Agenda
Village of Arlington Heights
Design Commission
Community Room, 3rd floor

- A. DC#18-104 - Arlington Block 425 -
Campbell/Chestnut/Highland / CBD Mixed-Use

MINUTES OF
THE VILLAGE OF ARLINGTON HEIGHTS
DESIGN COMMISSION MEETING
HELD AT THE ARLINGTON HEIGHTS MUNICIPAL BUILDING
33 S. ARLINGTON HEIGHTS RD.
FEBRUARY 26, 2019

UNDERGROUND PARKING GARAGE PLAN

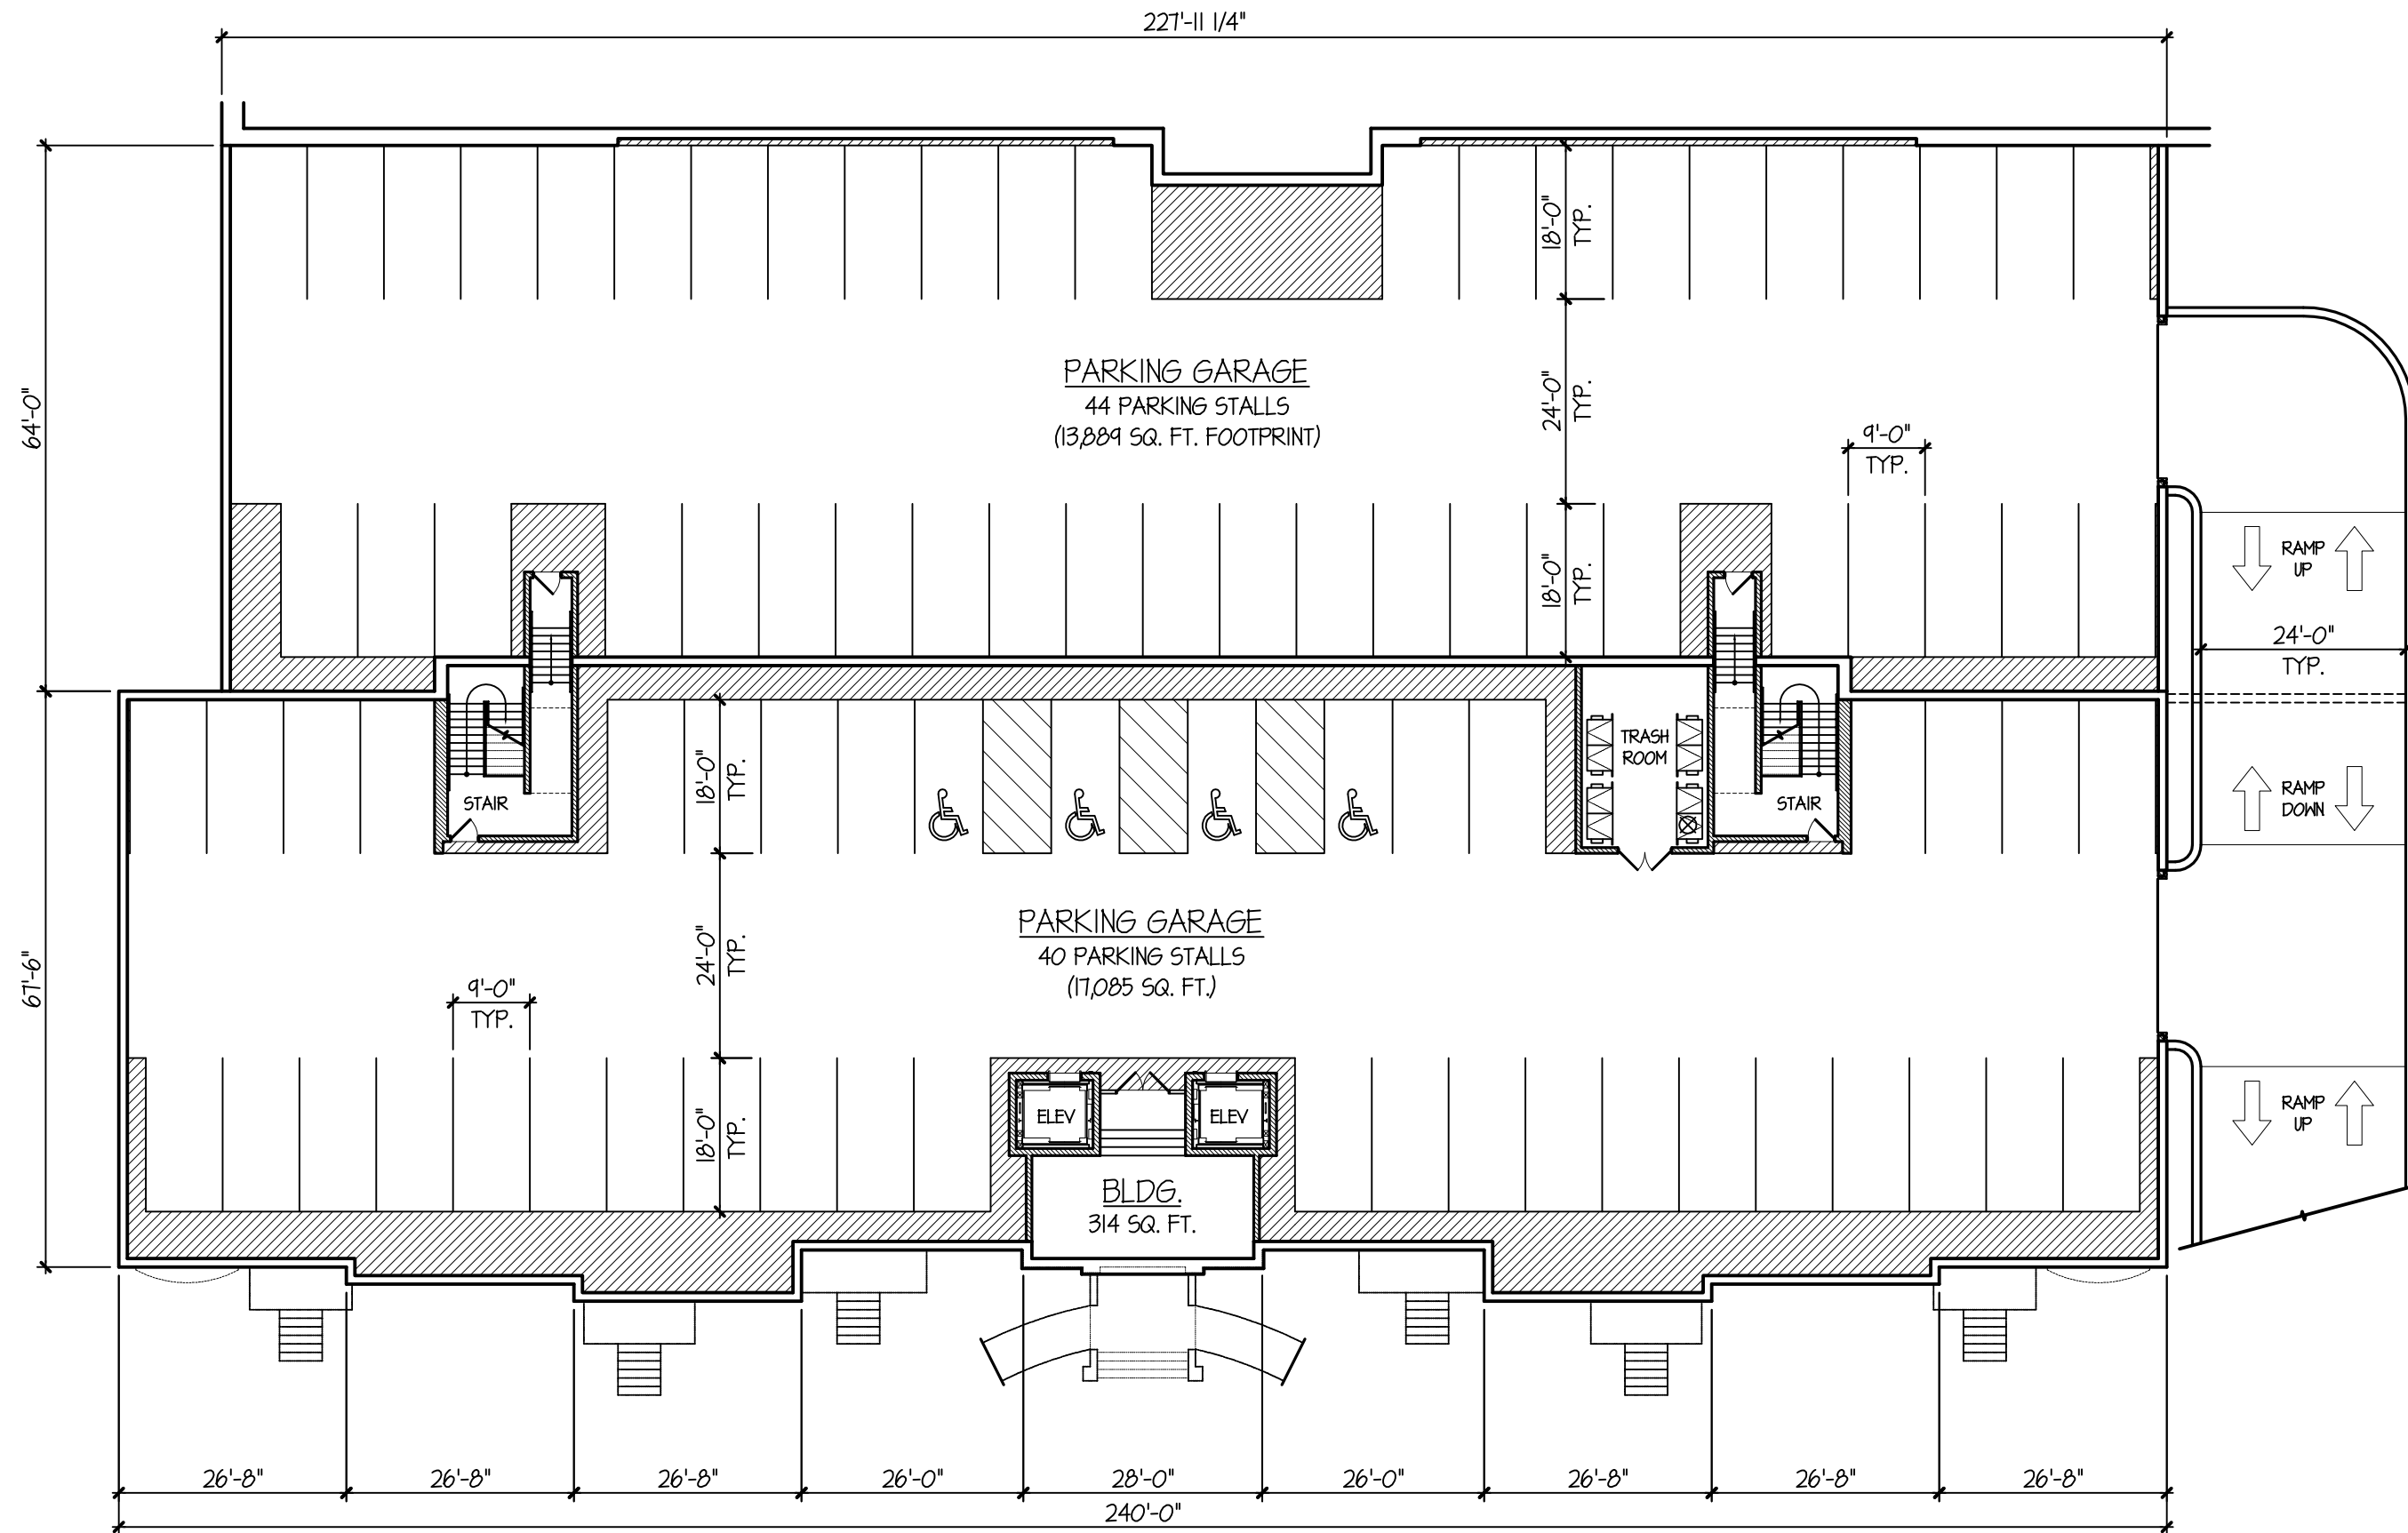
1. Chestnut building. Clarify the material and finish of the ramp walls going down to the garage.
2. Highland Avenue building. For a more cohesive appearance, it is recommended that the central curtain wall feature on the east elevation be revised with a curved bay to match the west elevation.

- **Chestnut Avenue Building:**
 - Overall, the proposed design is very nicely done, and the faux slate roofing is a nice enhancement to the design.
 - The petitioner needs to clarify the material and finish of the ramp walls going down to the garage. The renderings illustrate brick, and the architectural drawings show a large-format running bond. It was previously mentioned that this will be a concrete form liner. If so, the finish/color needs to be confirmed.

ARLINGTON 425: 44 S. HIGHLAND WEST ELEVATION

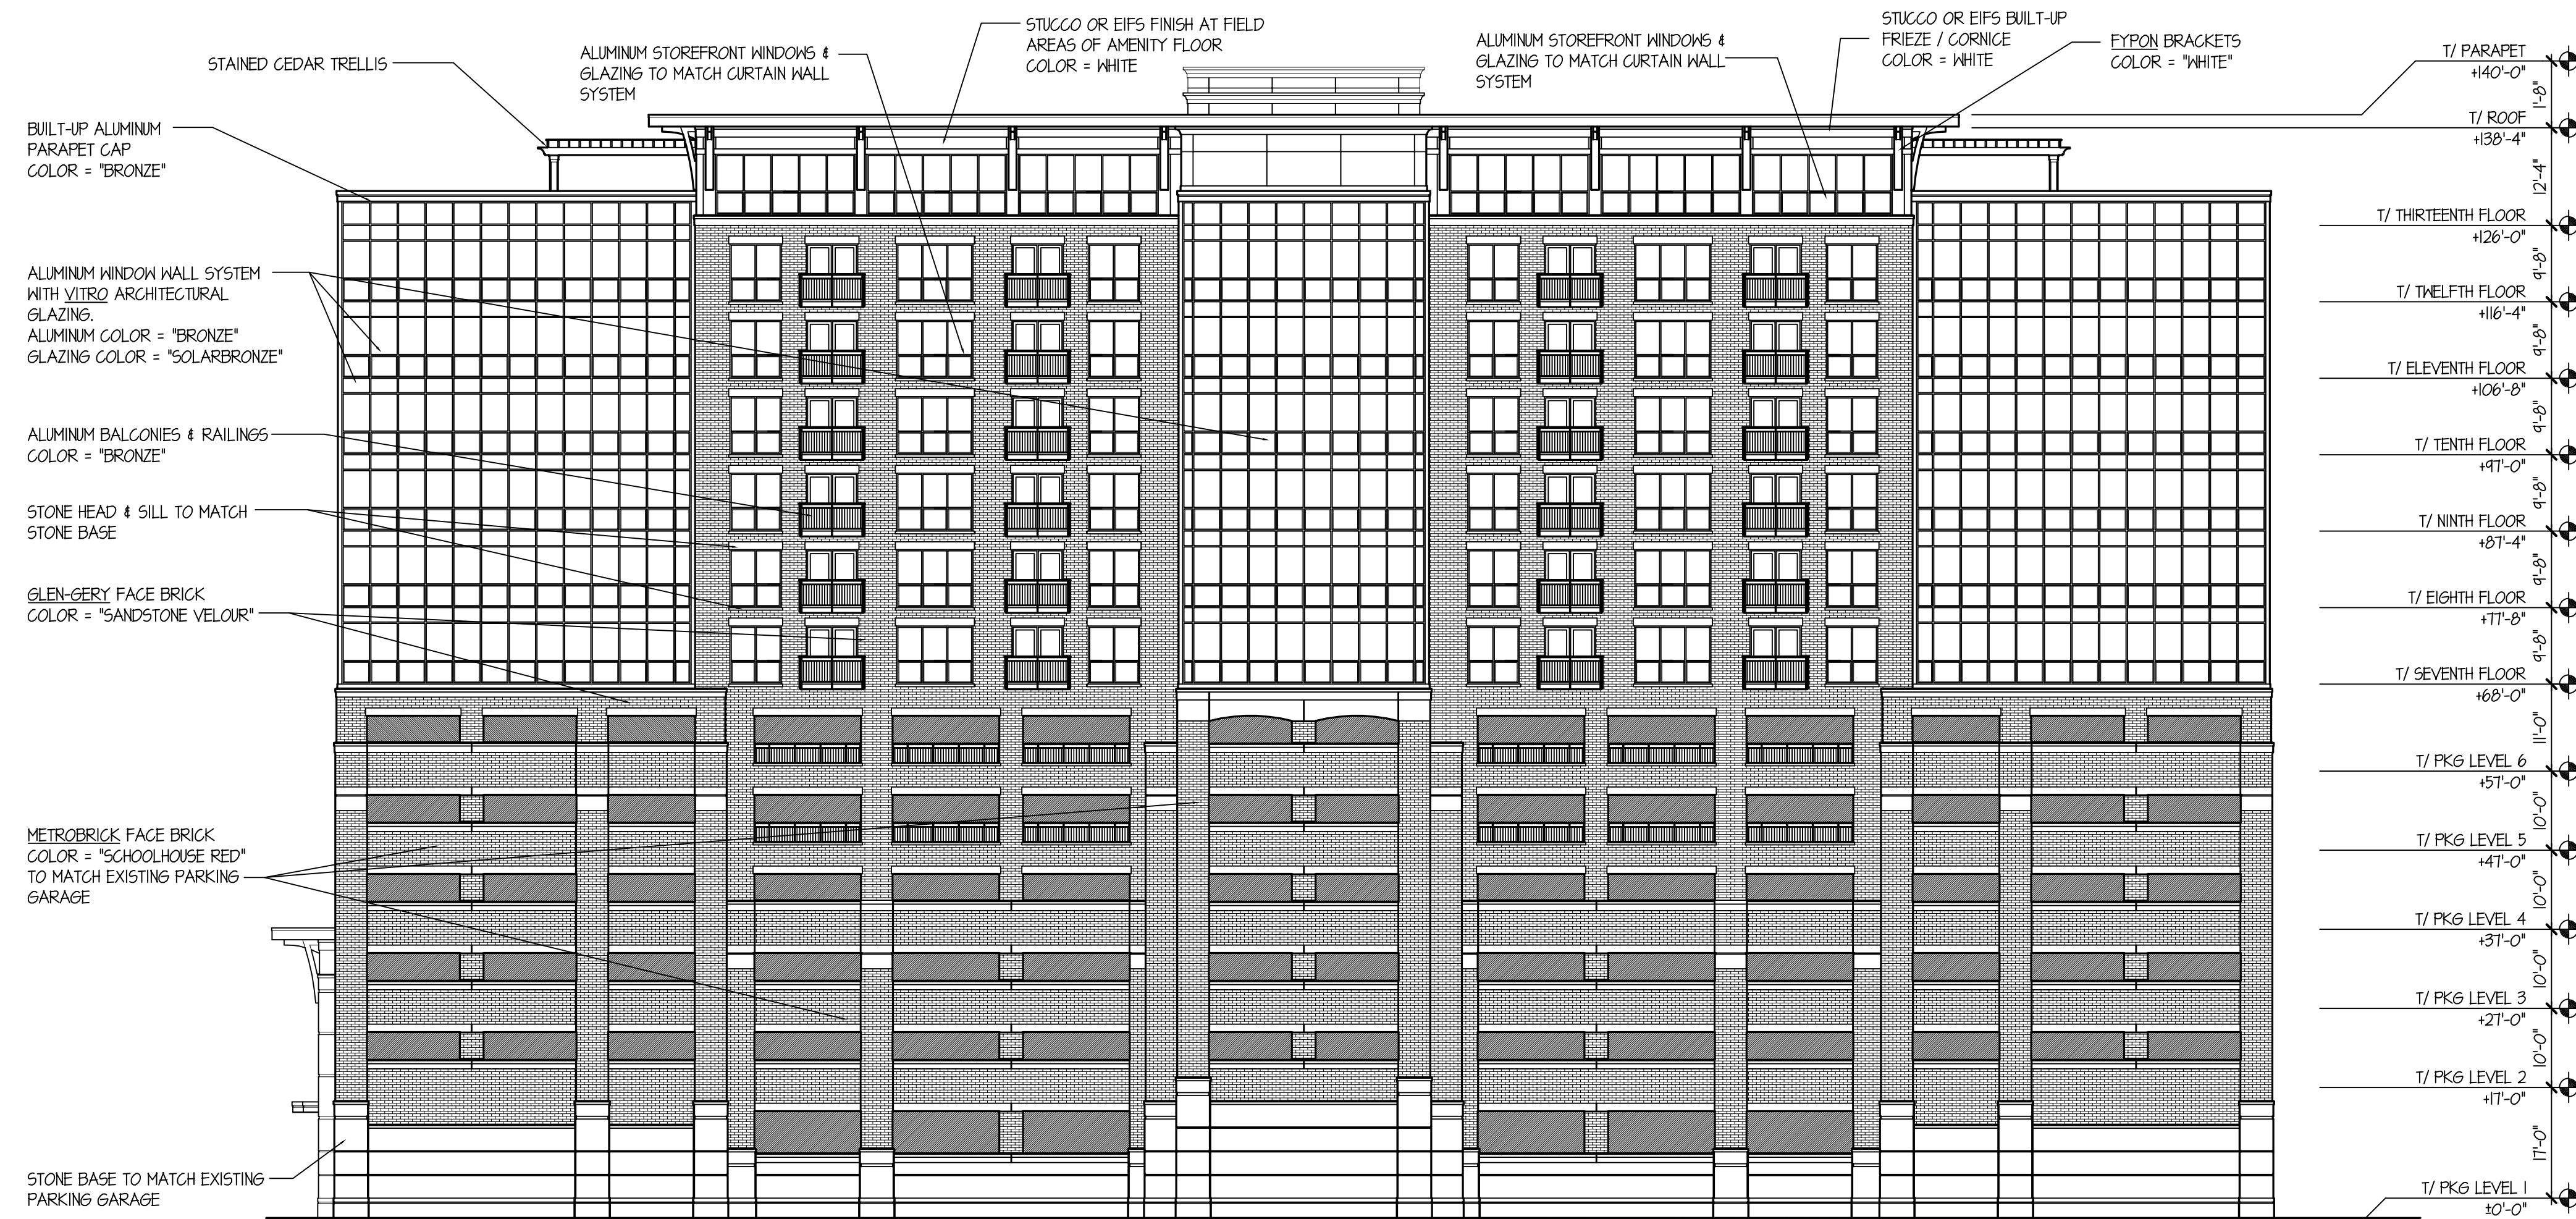
3. Highland Avenue building. The "44 S. Highland" wall sign is not allowed above the second floor ceiling. The sign should be revised to comply with code, or a sign variation would be required.

- The "44 S. Highland" wall sign is not allowed above the second floor ceiling. The sign should be revised to comply with code, or a sign variation would be required.

ARLINGTON 425: 44 S. HIGHLAND EAST ELEVATION

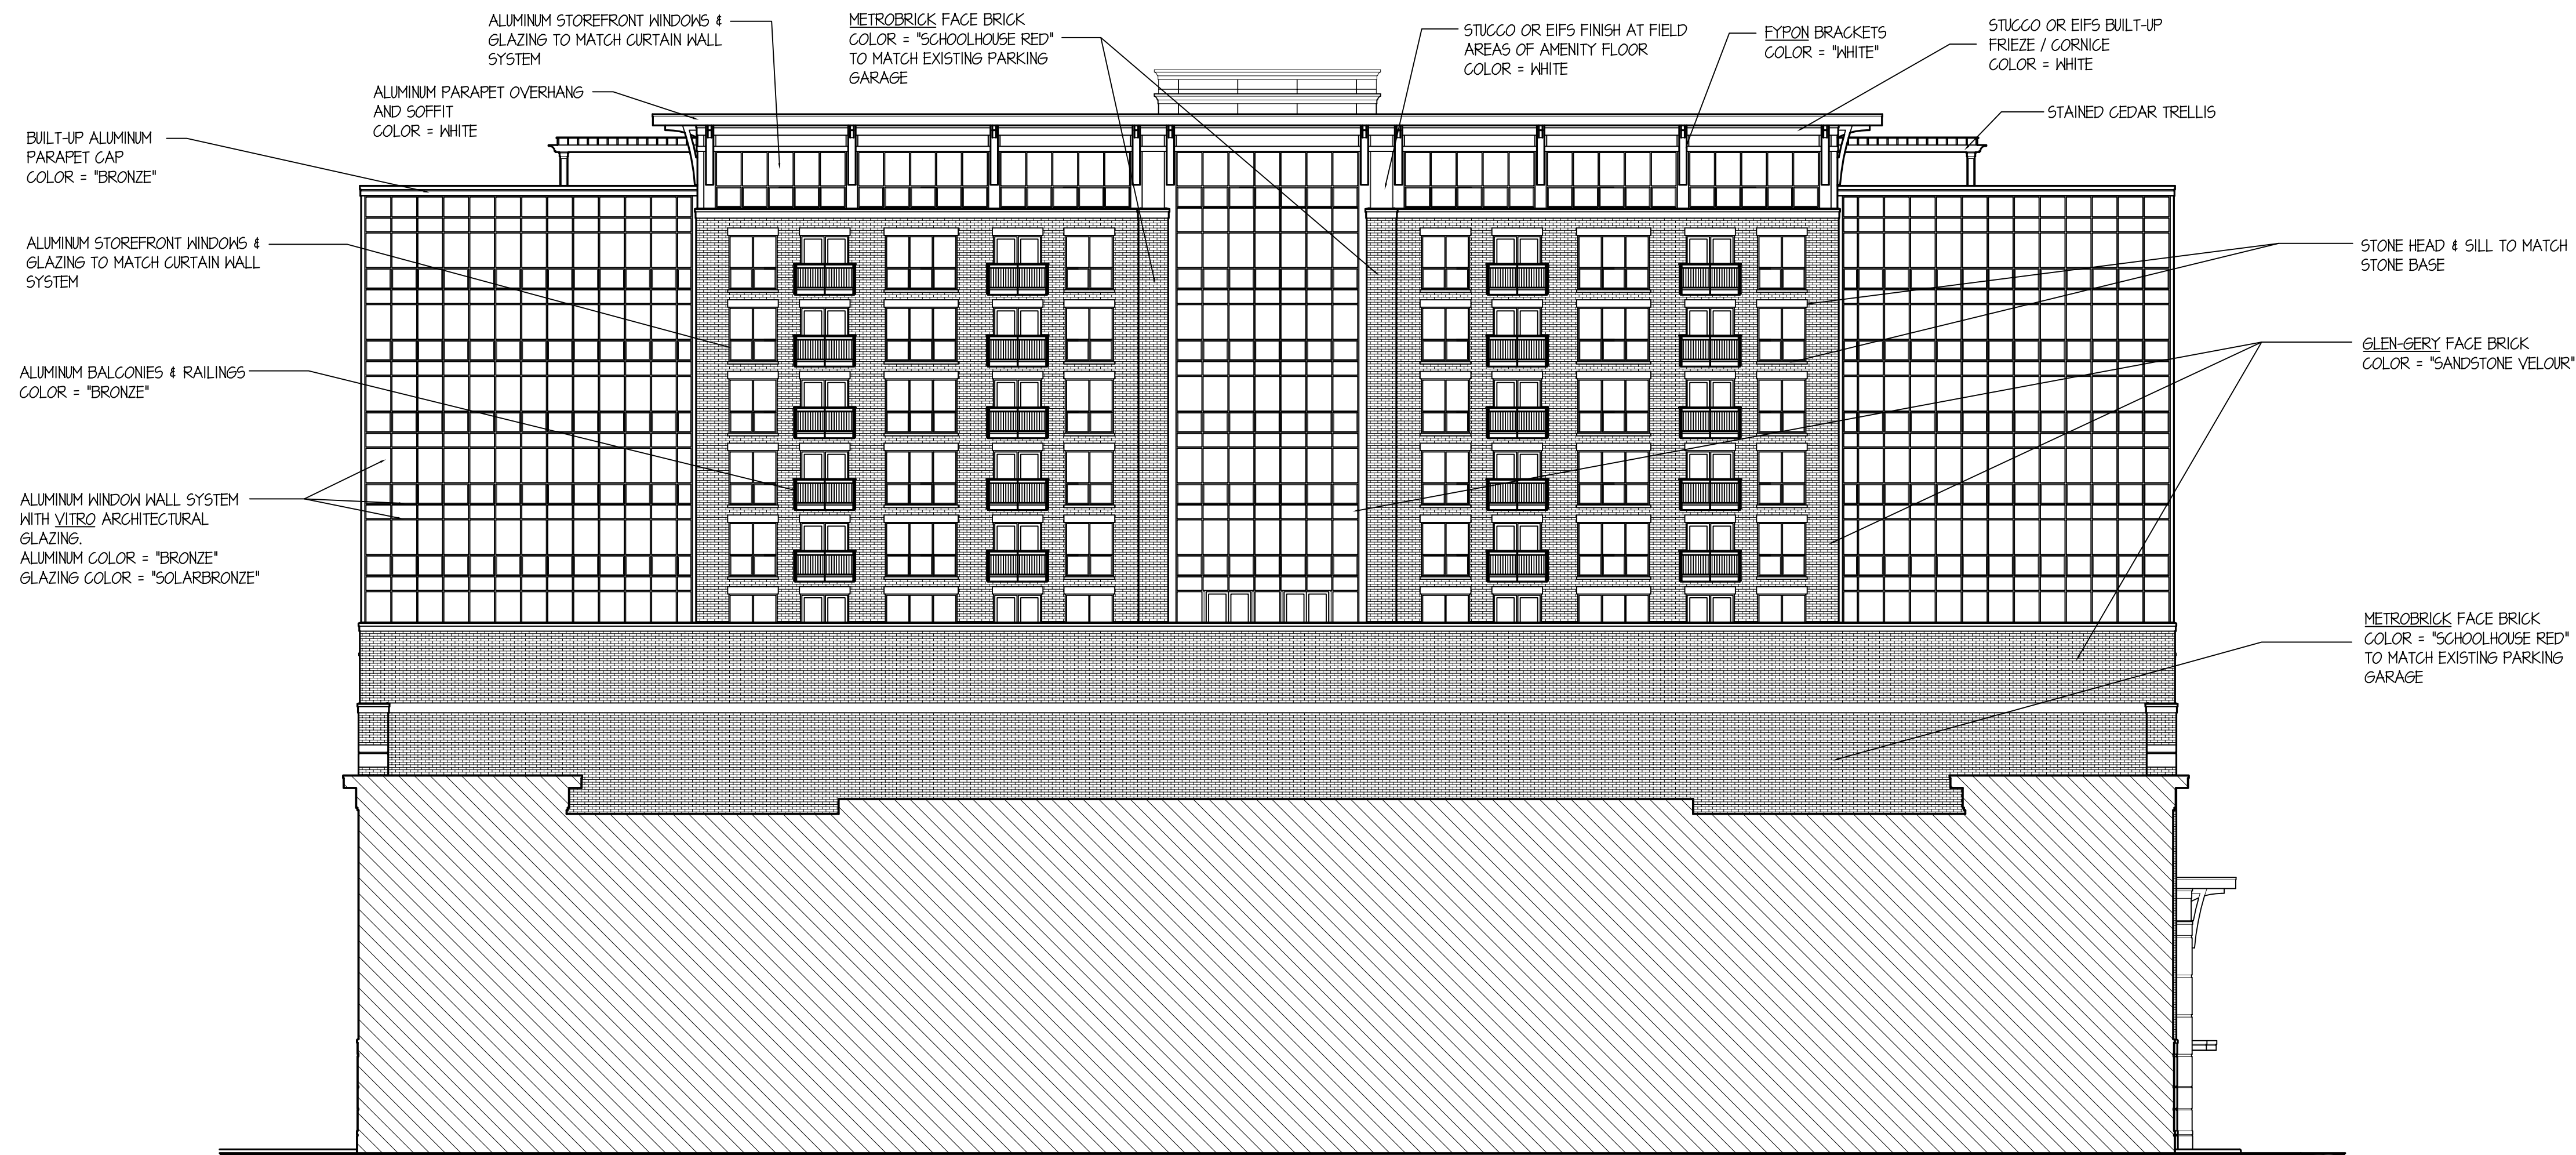
- For a more cohesive appearance, it is recommended that the central curtain wall feature on the east elevation be revised with a curved bay to match the west elevation.
